**ATTACHMENT 2  
BYLAW 17658  
BYLAW 17659  
FILE: LDA15-0459  
OLIVER**

**DESCRIPTION:** AMENDMENT TO THE OLIVER AREA REDEVELOPMENT PLAN

ZONING BYLAW AMENDMENT from (DC1) Direct Development Control Provision to (DC2) Site Specific Development; OLIVER

**LOCATION:** Located north of Jasper Avenue NW and east of 114 Street NW

**OLIVER, BYLAW 17659**

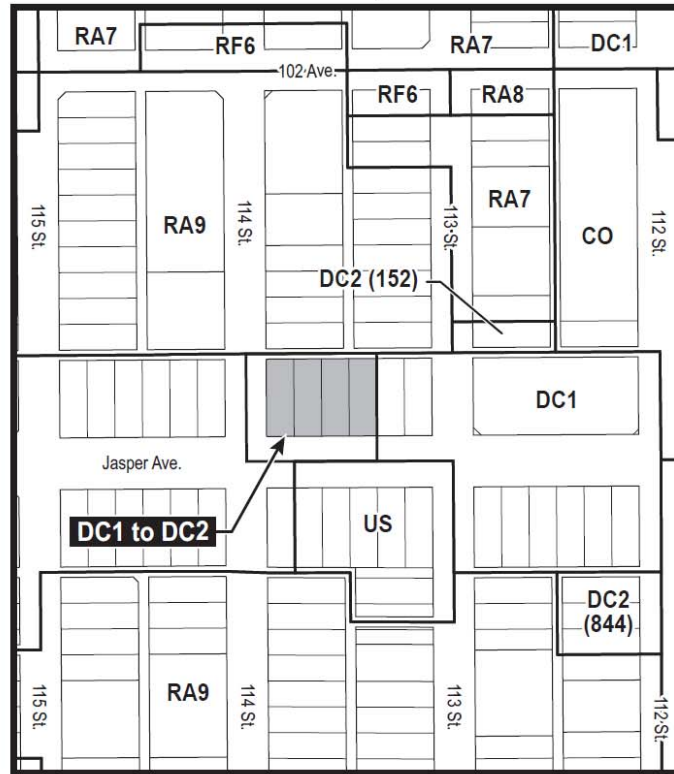
The purpose of proposed Bylaw 17659 is to change the Zoning Bylaw from (DC1) direct development control provision to (DC2) site specific development control provision, Lots 115 – 118, Block 13, Plan NB, as shown on the attached sketch. This zone provides the opportunity for a high rise mixed-use building up to 160 m high (approximately 45 storeys). The proposed building will provide retail and commercial uses at the street level, above grade parking within the podium base and residential uses within the tower portion. A maximum of 273 dwellings, a Floor Area Ratio of 12.4, and a maximum Floor Plate of 650 square meter is proposed. An associated Oliver Area Redevelopment Plan amendment, Bylaw 17658, is proceeding to Council concurrently with this bylaw. Sustainable Development does not support this proposed bylaw.
